# UNITED STATES PATENT AND TRADEMARK OFFICE

| APPLICATION NO. | FILING DATE | FIRST NAMED INVENTOR | ATTORNEY DOCKET NO. | CONFIRMATION NO. |
|-----------------|-------------|----------------------|---------------------|------------------|
| 09/473,315      | 12/28/1999  | LARRY EUGENE MOSLEY  | 884.209US1          | 9830             |

# Office Action Summary

## DETAILED ACTION

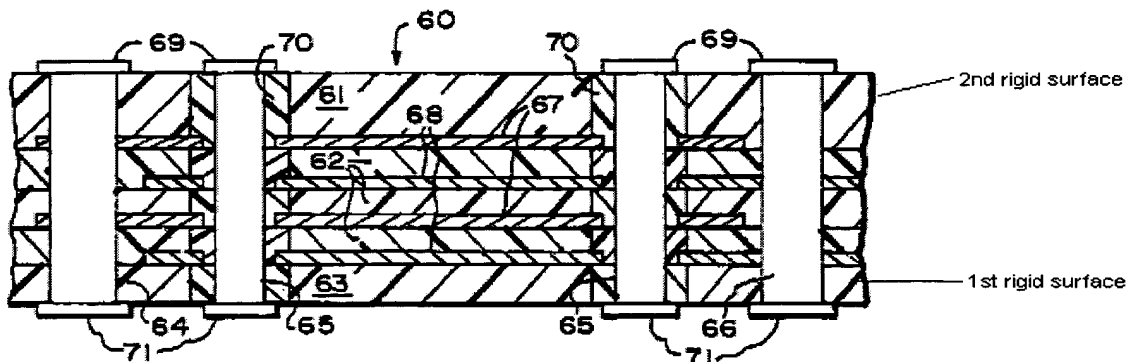
Regarding claim 9, Farooq et al. disclose in fig. 3 A, a multilayer capacitor having a pair of outer surfaces (see below), and a number of pads (69) located on two of the number of outer surfaces; wherein two of the number of pads are capable of being coupled to a substrate using a solder bump. Although Farooq et al. do not expressly state that the outer surfaces are "substantially rigid"; it is an inherent feature of the capacitor of Farooq et al. (see method of forming the capacitor – a fired ceramic green sheet produces a "substantially" rigid surface).

Regarding claim 10, the multilayer capacitor includes a number of parallel conductive layers and the number of pads coupled to the number of parallel conductive layers through vias.
